SIEMENS

January 27, 1997
JBE:97:014

License No. SNM-1227
Docket No. 70-1257

- Ref.: 1. Letter, K. J. Hardin to L. J. Maas, "Request for Additional Information, Low Level Radioactive Waste Shredding and Uranium Recovery", (TAC NO. L30896), dated December 10, 1996.
2. Letter, K. J. Hardin to L. J. Maas, "Request for Additional Information, Low Level Radioactive Waste Shredding and Uranium Recovery", (TAC NO. L30896), dated December 23, 1996.

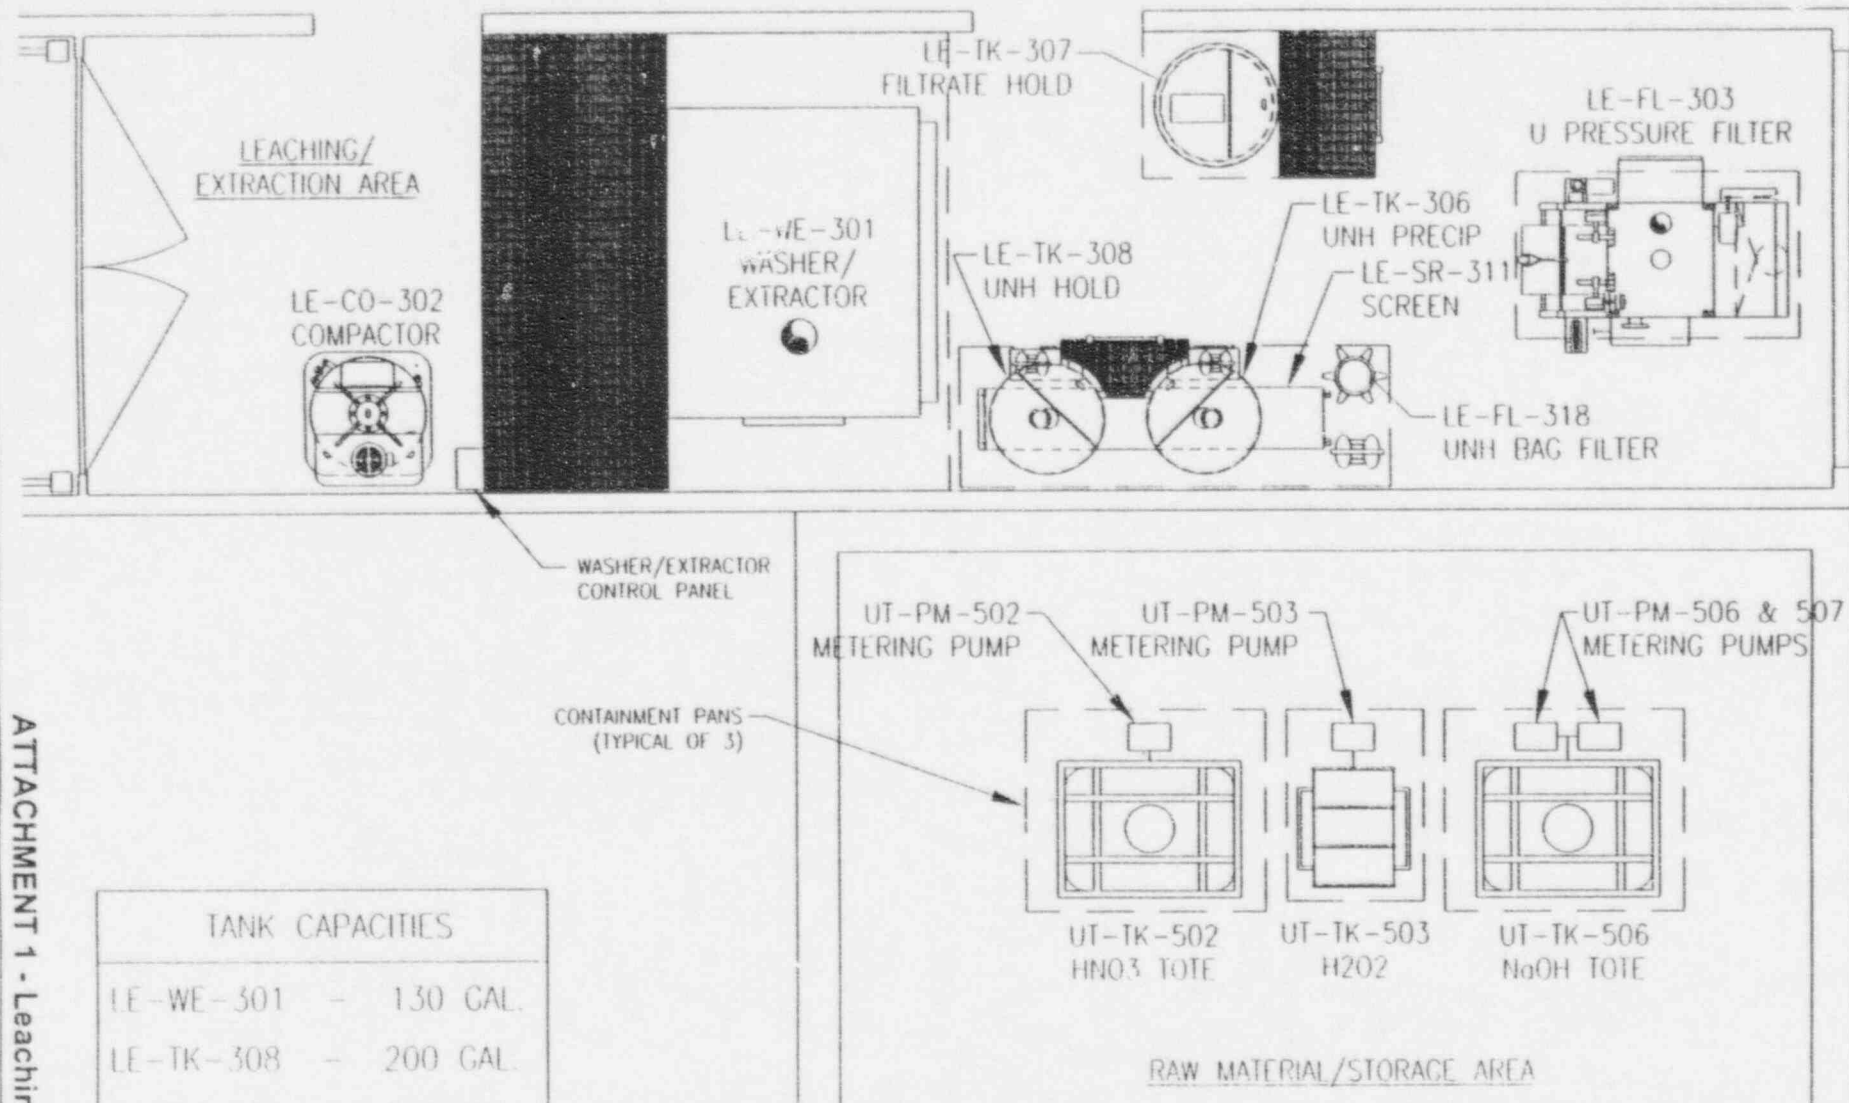
2. Provide a summary of the criticality safety analysis, including parameter safety limits and margins of safety and how they were derived.

As previously stated, the parameters controlled are mass and enrichment. The SPC facility is limited to an enrichment of 5 wt.% ^{235}U . Section 4.2.3.1 of the operating license establishes the minimum safety margin, when using mass control, at 45% of the minimum critical mass ("safe" mass) being

processed. This section also details the additional controls that must be used.

Table II.14.2 of the operating license provides the basis for critical and safe masses. For 5 wt.% enriched material the safe mass of UO_2 is 18.0 kg. This is equivalent to 15.8 kg U or 790 grams ^{235}U (the actual average enrichment of SPC's waste is approximately 3.5%). The process is controlled to 450 grams ^{235}U , thus ensuring that the process will conservatively remain well below the 790 gram ^{235}U safety limit, and the minimum critical mass of 1756 g ^{235}U , when considering the random and systematic errors associated with the NDA of this material. The safety margin in terms of mass is approximately 3.9 (1756/450).

ATTACHMENT 2 - Washer/Extractor (LE-WE-301)

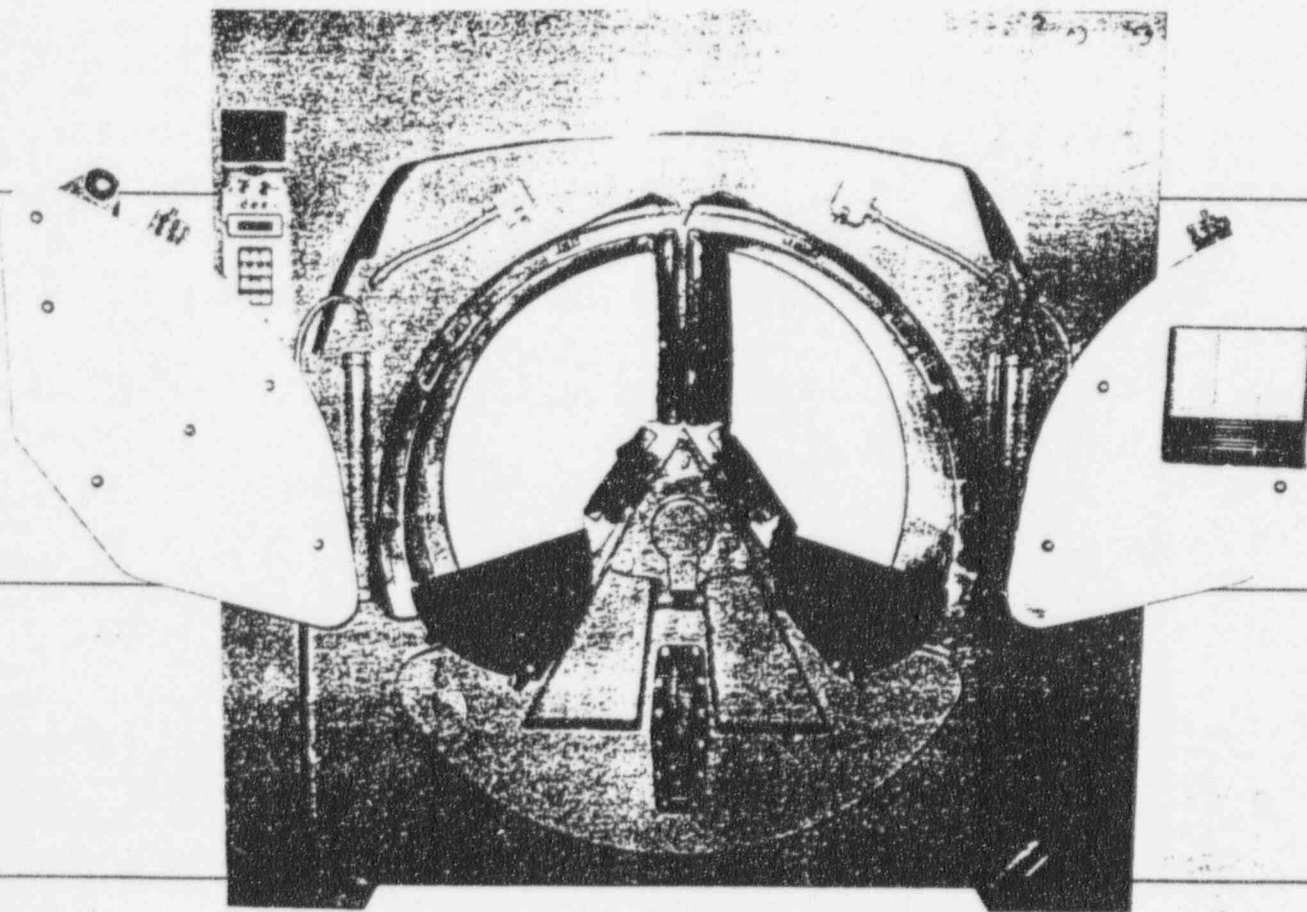
1.1 Describe the equipment used for leaching, including vessel sizes, maximum quantity of the acid leaching fluid and feed in a batch, and a drawing or a schematic of the proposed layout of the equipment in relation to the module.

The leaching equipment layout is shown in Attachment 1. The leaching process is carried out in a stainless steel commercial washer/extractor manufactured by the Pellerin-Milnor Corporation of New Orleans, LA. The particular washer/extractor model is described in further detail in the vendor literature in Attachment 2. The washer drum holds a maximum of 130 U.S. gallons of leachant and will normally contain a maximum of approximately 300 pounds of feed material during wet waste processing. The normal maximum weight of the feed material during processing of HEPA and prefilter media will be on the order of 160 pounds. The washer/extractor drum is a horizontal cylinder that is 60 inches in diameter and 44 inches deep.

ATTACHMENT 4 - Entry Doorway

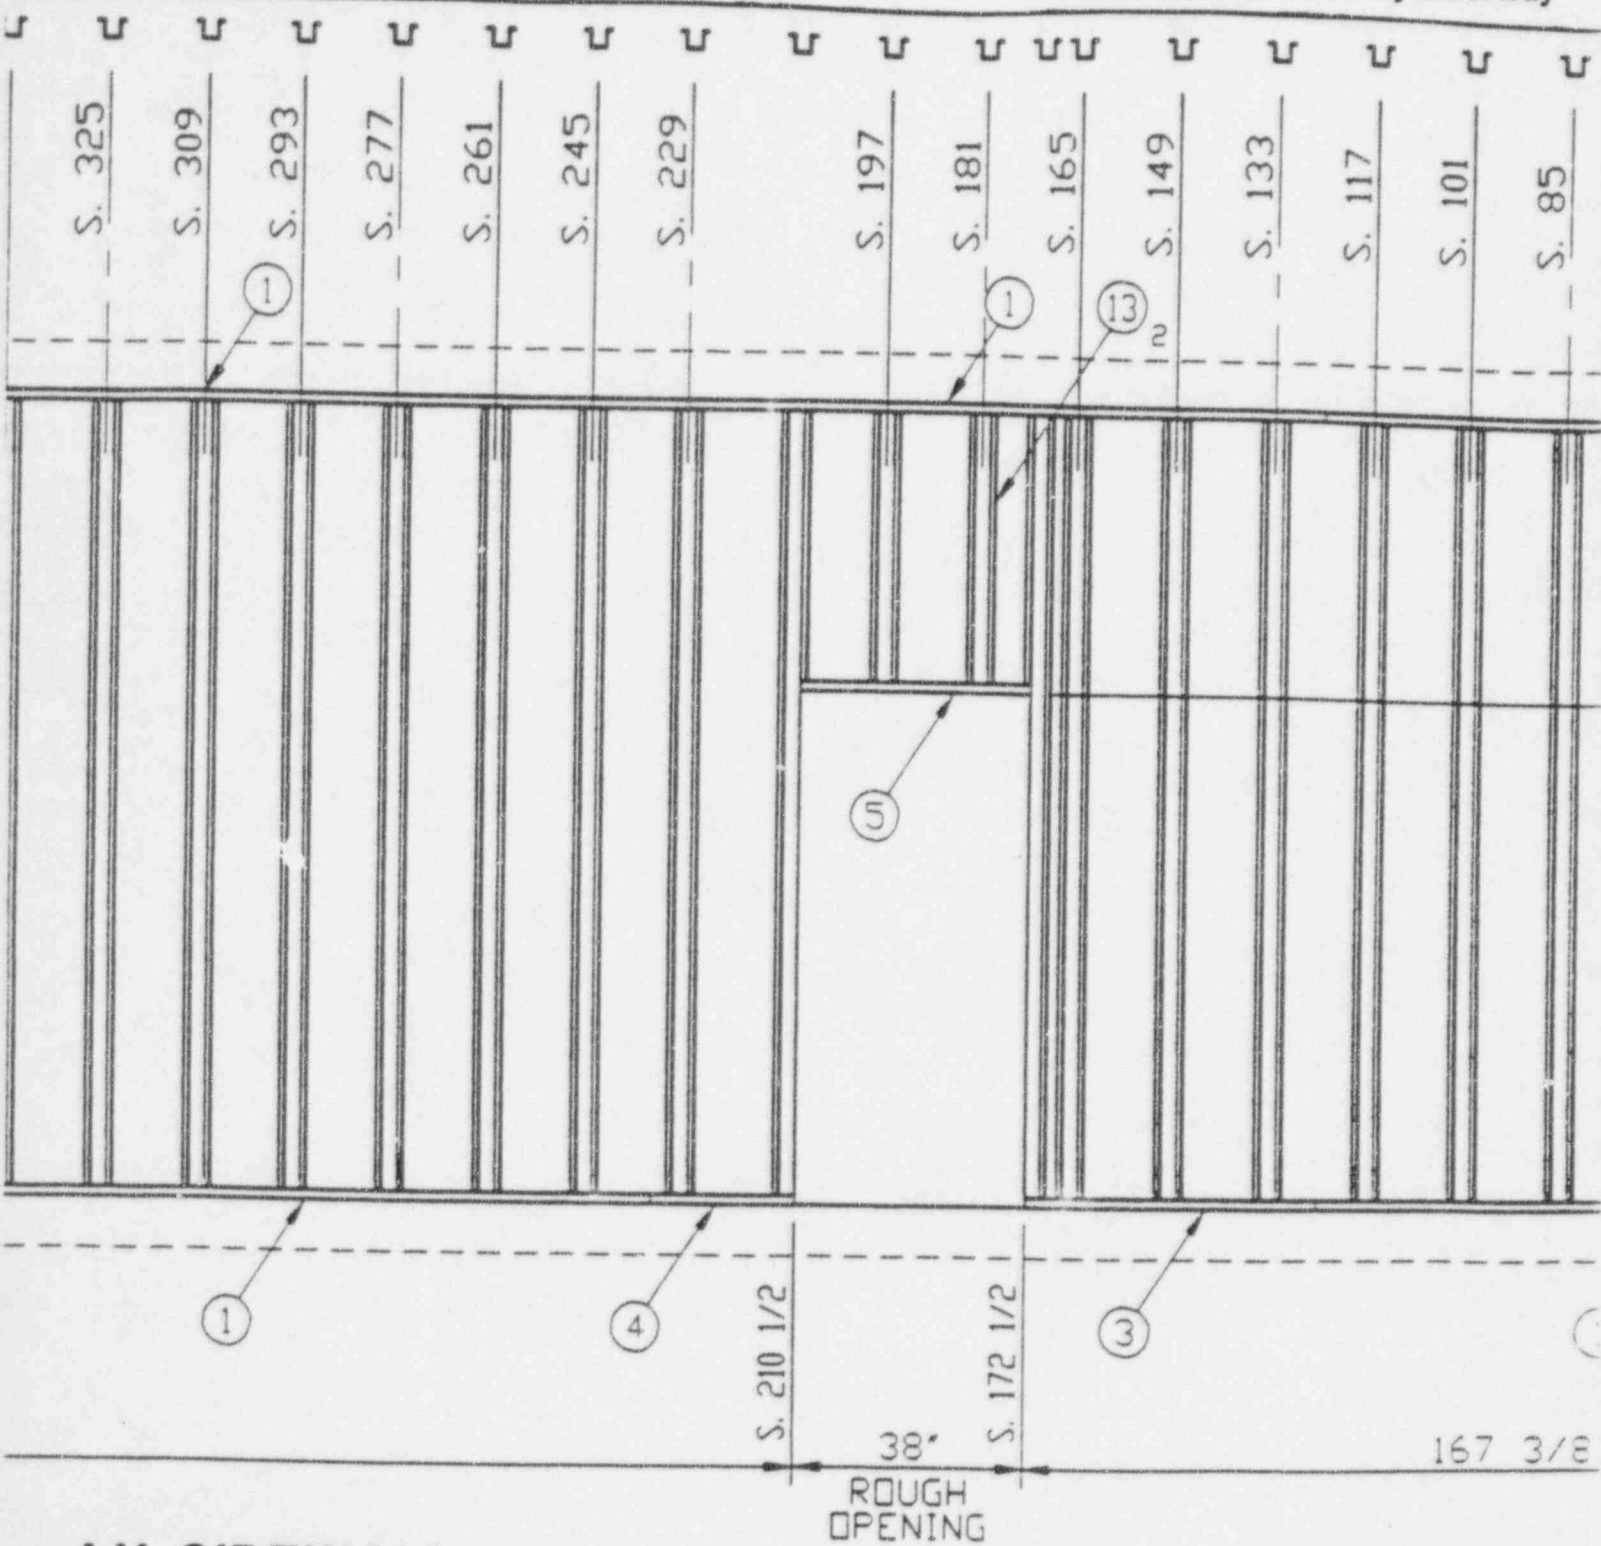
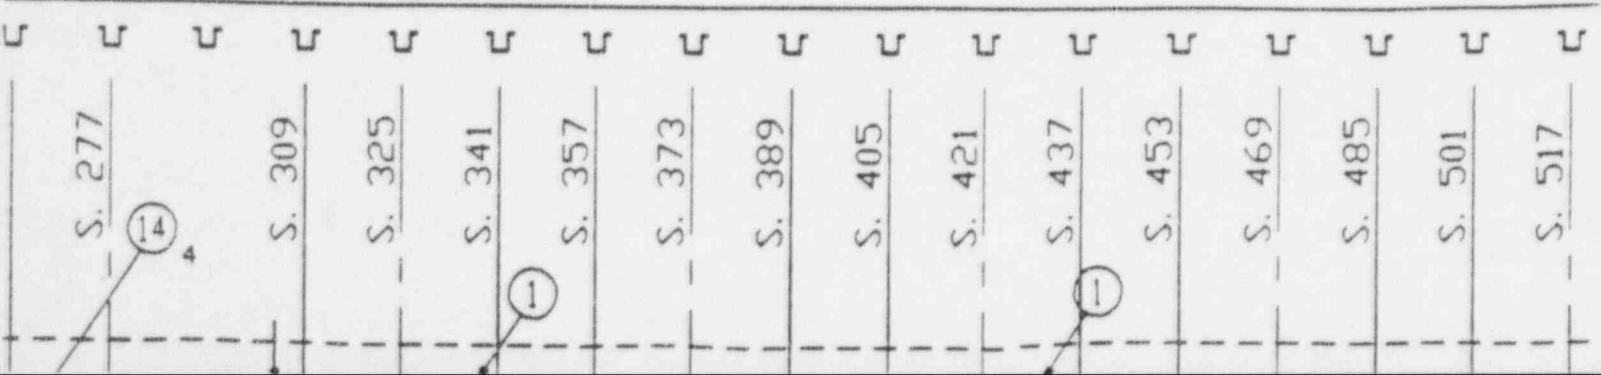
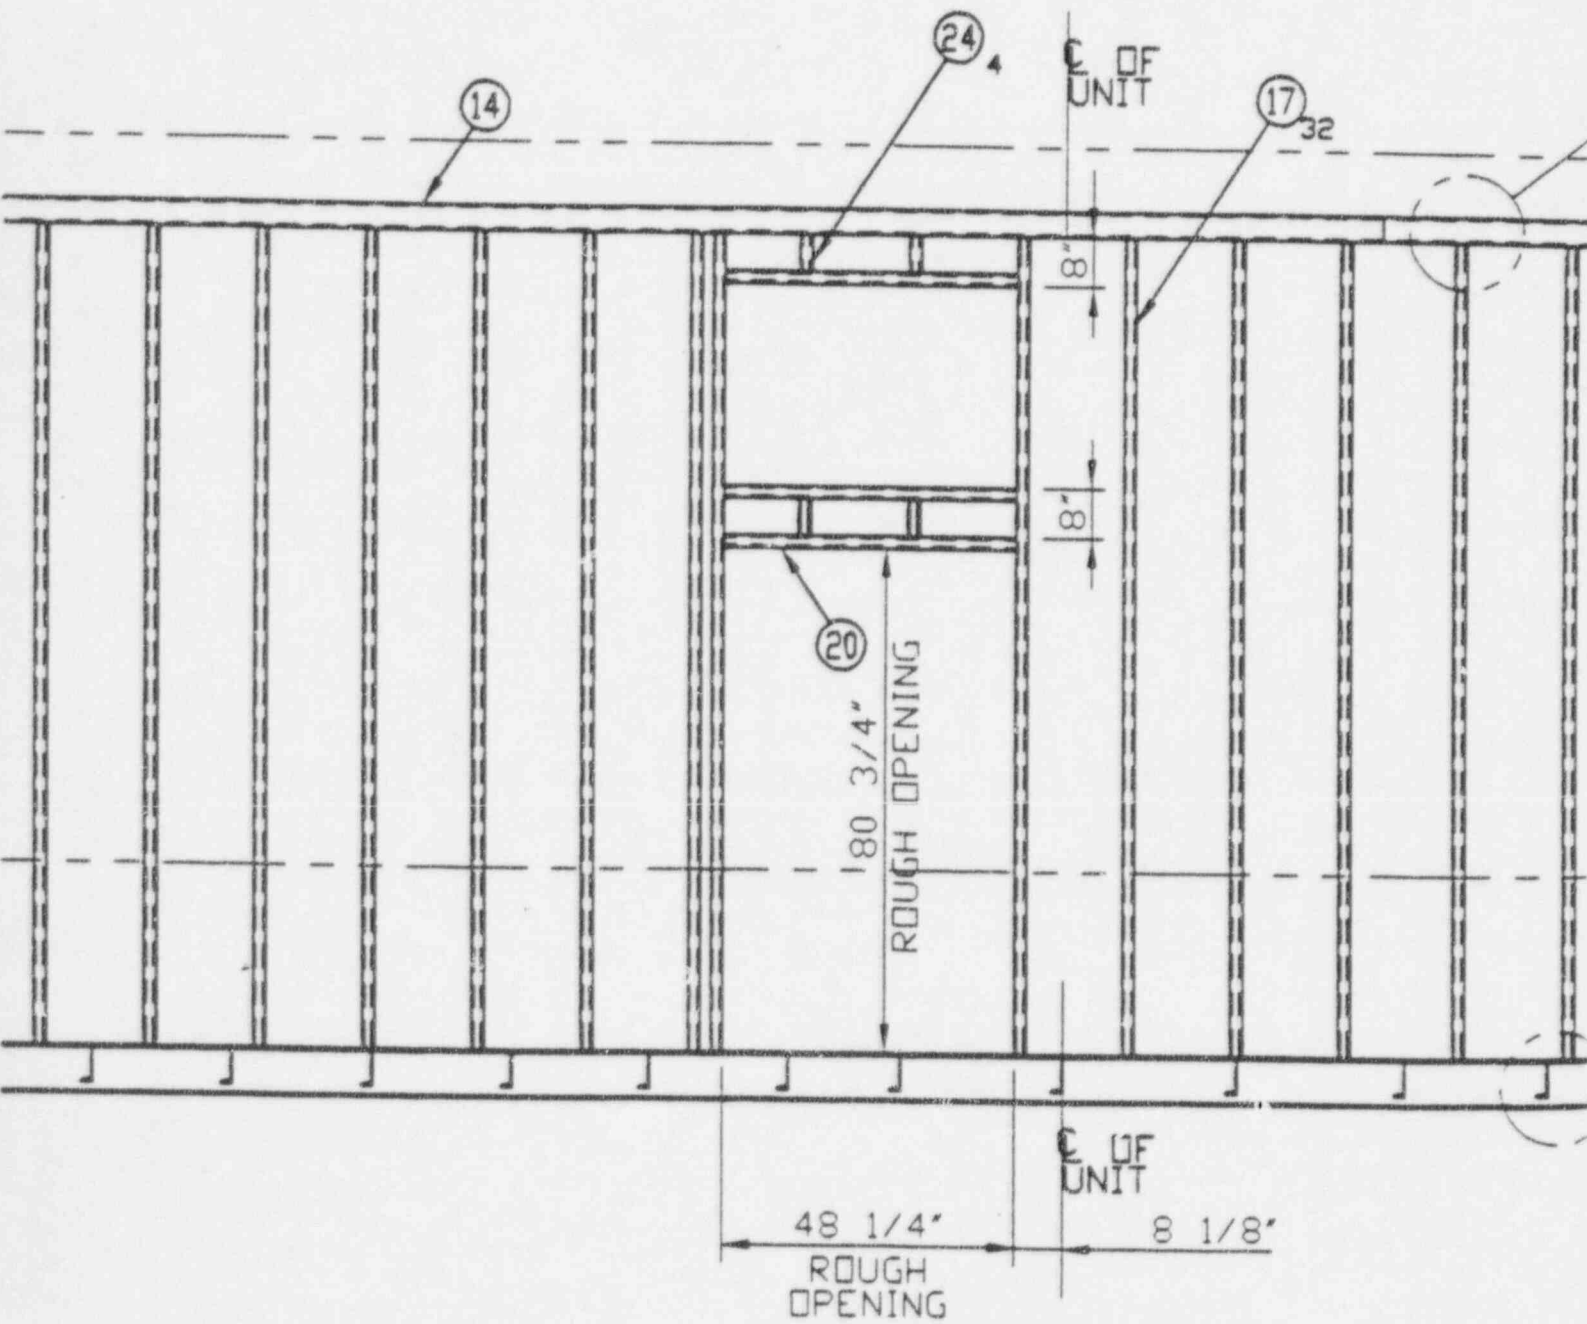
- 2.2 List all doors or other openings providing thoroughfare between the modules and buildings, including ventilation openings. Alternatively, provide a detailed drawing showing such openings.

There are four doorways within the MERF facility that provide for normal thoroughfare between the modules. These include the personnel entry doorway (shown in detail on Attachment 4) and the interior personnel doorways (shown in detail on Attachment 5). The main personnel entry door (Attachment 4) employs a 2" thick metal door with a 2'x2' reinforced safety glass window. Because there is no fire area separation within the MERF, this door is not fire rated. The interior personnel doorways (Attachment 5), of which there are three within the facility, are open passageways with no doors. The openings are sealed with two-piece "plug-doors", one from inside and one from outside, for transportation and storage. Since all ventilation airflows are "hard piped" within the MERF, there are no "ventilation openings".
